ADDENDUM

Addendum No.: 1
Project Name: Sixth Street Sanitary Sewer Replacement
Project No. 2020-013-08
Date: January 5, 2021
To: All Bidders

3800-5

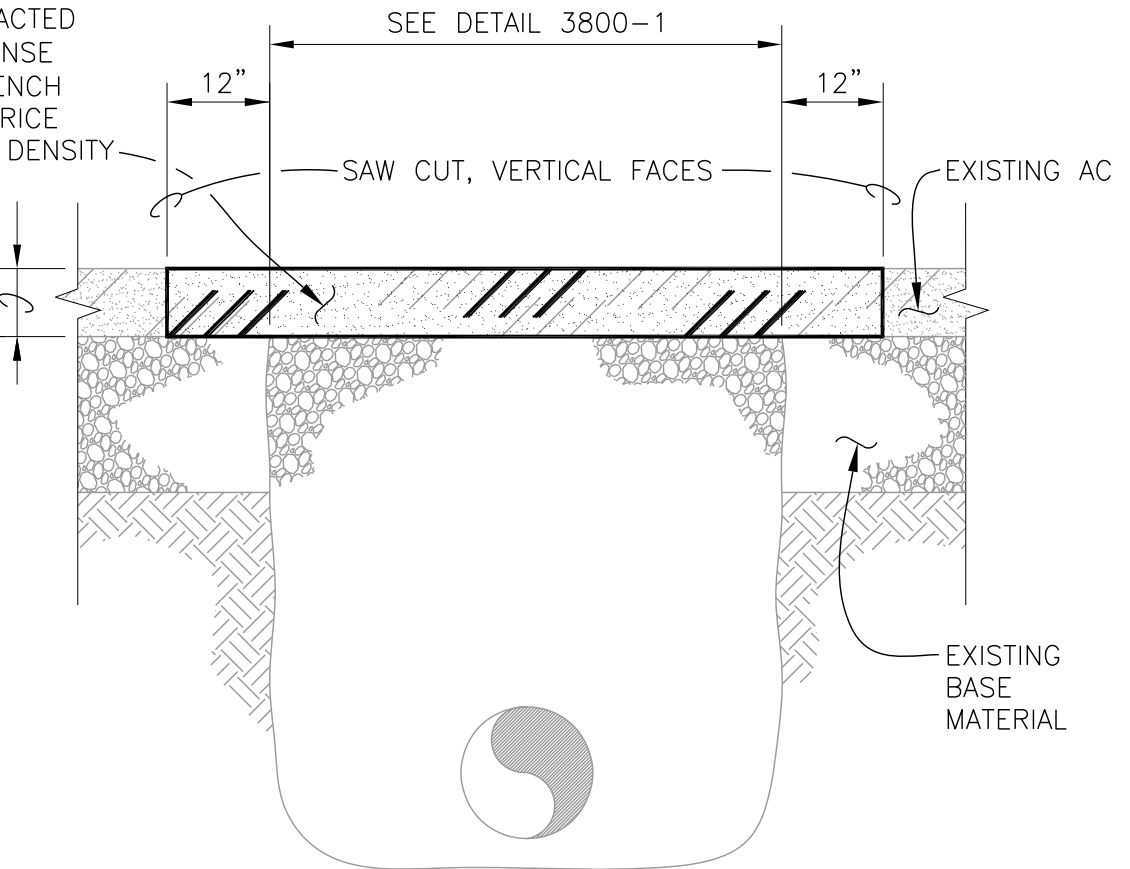
Replace Standard Detail 3800-5 with the attached Revised Standard detail 3800-5 showing a minimum 4" HMA thickness.
